Access Compliance Report

Public Rights-of-Way

Intersection ID: 12618	Main Street: E_5TH_ST	Cross Street: N_CALDWELL_ST	Location: NW
ADA ID: 2A18590F718E	Ramp Type: Perp	Initial Pass/Fail: Fail	Overall Compliance: No
		Severity Score: 12.5

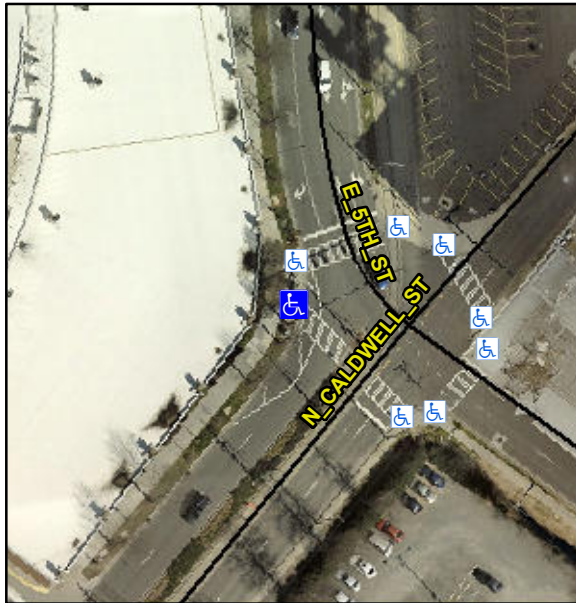
Not Found, R304.5.3

Compliance	Description	Data	Compliance	Description	Data
N/A	Ramp Length (in)	67.0	Yes	Ramp Slope (%)	7.4
Yes	Ramp Width (in)	48.0	No	Ramp XSlope (%)	5.2
N/A	Flare Type LT	N/A	N/A	Flare Type RT	N/A
N/A	Flare Slope LT (%)	N/A	N/A	Flare Slope RT (%)	N/A
N/A	Flare Traversable LT?	N/A	N/A	Flare Traversable RT?	N/A
N/A	Landing Length (in)	N/A	N/A	DWS Provided?	N/A
N/A	Landing Width (in)	N/A	N/A	DWS Contrast?	N/A
N/A	Landing Slope (%)	N/A	N/A	DWS Length (in)	N/A
N/A	Landing X Slope (%)	N/A	N/A	DWS Full Width?	N/A
N/A	Landing Curb? (Y/N)	N/A	N/A	DWS Offset (in)	N/A
N/A	Shared Landing?	N/A			
N/A	Gutter Ponding?	N/A	N/A	Gutter Slope (%)	N/A
N/A	Gutter Lip Ht (in)	N/A	N/A	Gutter X Slope (%)	N/A
N/A	Painted X Walk1?	Yes	N/A	Painted X Walk2?	N/A
	X Walk 1 Direction	To SE		X Walk 2 Direction	N/A
N/A	X Walk 1 Width (in)	128.0	N/A	X Walk 2 Width (in)	N/A
	X Walk 1 Slope (%)	0.5		X Walk 2 Slope (%)	N/A
	X Walk 1 X Slope (%)	3.8		X Walk 2 X Slope (%)	N/A

Remove & Replace Entire Ramp.
